Amendments to the Drawings:

REMARKS/ARGUMENTS

FIG. 3a

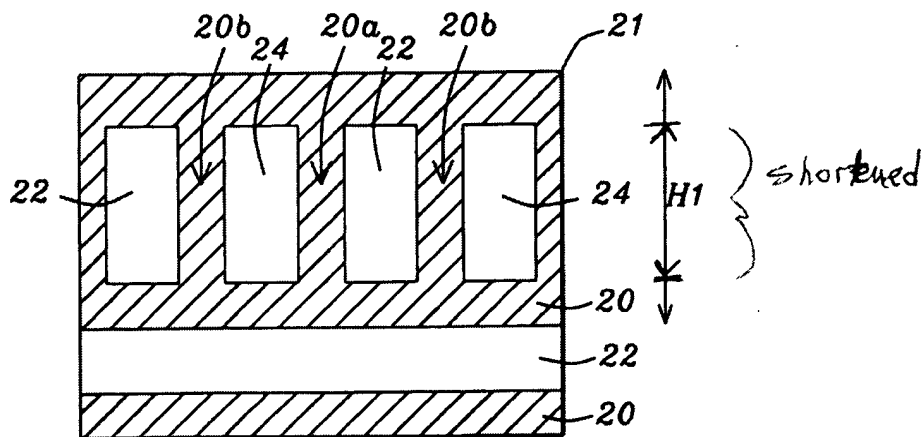
The attached sheets of drawings include changes to FIG. 3a and FIG. 7. The sheet that includes FIGS. 3a, 3b, and 4a replaces the original sheet which includes FIGS. 3a, 3b, and 4a. In FIG. 3a, the length of the double headed arrow H1 has been shortened. The sheet that includes FIG. 7 replaces the original sheet which includes FIG. 7. In FIG. 7, the spelling of "Position" on the x-axis has been corrected.

The drawing in FIG. 3a has been changed to correct the phase height H1 which is defined on page 13, lines 13 -14 as the height of the opening in regions 22 and 24. The drawing in FIG. 7 has been changed to correct the spelling of the word "position".

FIG. 7

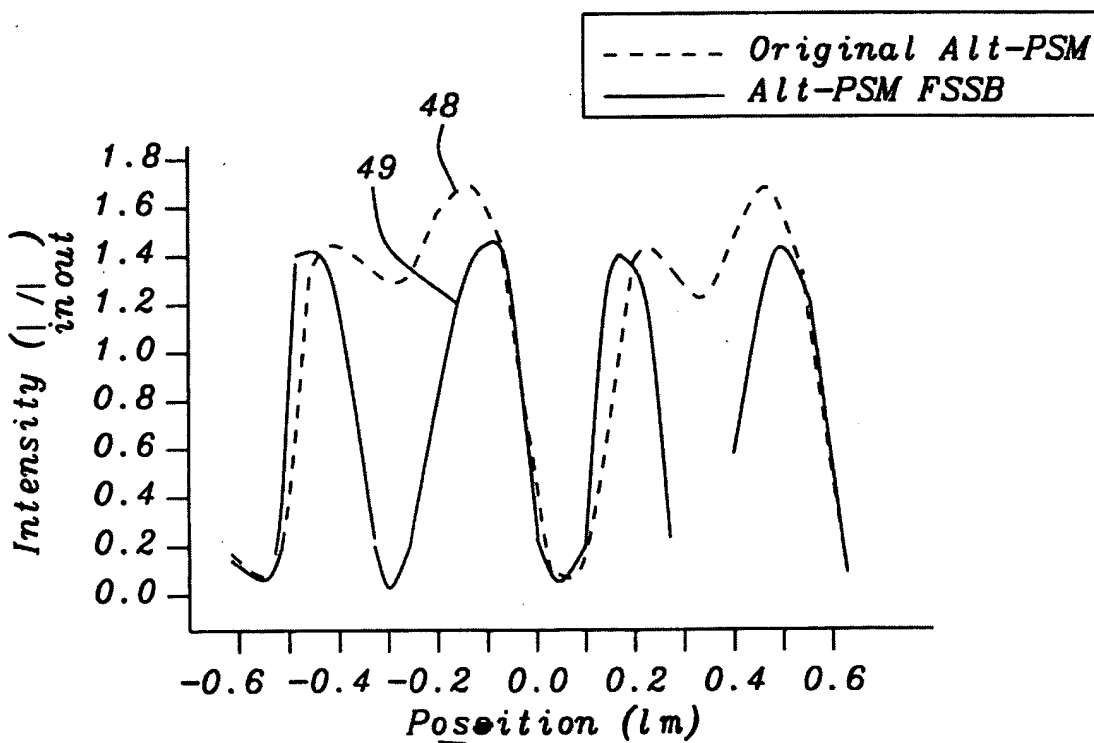
"s" removed
